# Access Compliance Report

## Public Rights-of-Way

### (Curb Ramps)

Intersection ID: 45495	Main Street: COTTON_PRESS_RD	Cross Street: TREE_CANOPY_RD	Location: N
ADA ID: C442137A3D52	Ramp Type: PerpDiag	Initial Pass/Fail: Fail	Overall Compliance: No
Severity Score: 26.25			
Codes/Mitigation Info/Possible Solution		Field Measurements/Component Compliance

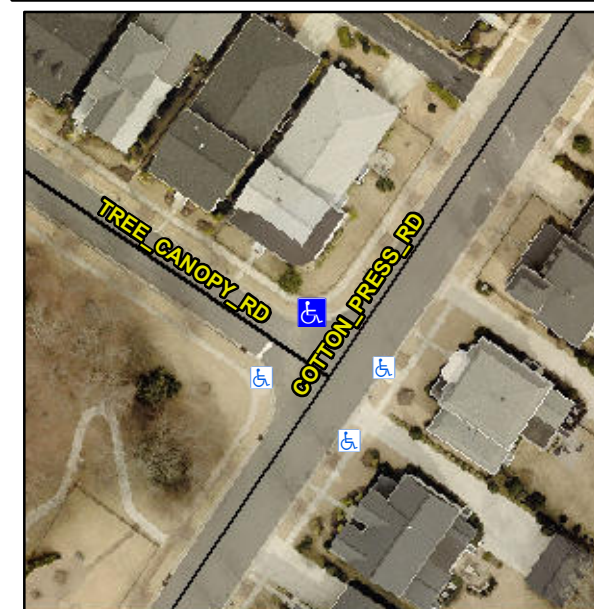
**Not Found, R304.2.2, R304.5.3**

Compliance	Description	Data	Compliance	Description	Data
N/A	Ramp Length (in)	69.0	No	Ramp Slope (%)	16.2
Yes	Ramp Width (in)	48.0	No	Ramp XSlope (%)	3.1
N/A	Flare Type LT	N/A	N/A	Flare Type RT	N/A
N/A	Flare Slope LT (%)	N/A	N/A	Flare Slope RT (%)	N/A
N/A	Flare Traversable LT?	N/A	N/A	Flare Traversable RT?	N/A
N/A	Landing Length (in)	N/A	N/A	DWS Provided?	N/A
N/A	Landing Width (in)	N/A	N/A	DWS Contrast?	N/A
N/A	Landing Slope (%)	N/A	N/A	DWS Length (in)	N/A
N/A	Landing X Slope (%)	N/A	N/A	DWS Full Width?	N/A
N/A	Landing Curb? (Y/N)	N/A	N/A	DWS Offset (in)	N/A
N/A	Shared Landing?	N/A			
N/A	Gutter Ponding?	N/A	N/A	Gutter Slope (%)	N/A
N/A	Gutter Lip Ht (in)	N/A	N/A	Gutter X Slope (%)	N/A
N/A	Painted X Walk1?	No	N/A	Painted X Walk2?	No
	X Walk 1 Direction	To SW		X Walk 2 Direction	To SE
N/A	X Walk 1 Width (in)	N/A	N/A	X Walk 2 Width (in)	N/A
	X Walk 1 Slope (%)	2.6		X Walk 2 Slope (%)	4.1
	X Walk 1 X Slope (%)	0.4		X Walk 2 X Slope (%)	0.1

**Remove & Replace Curb Ramp With Two New Directional Ramps or Equivalent.**
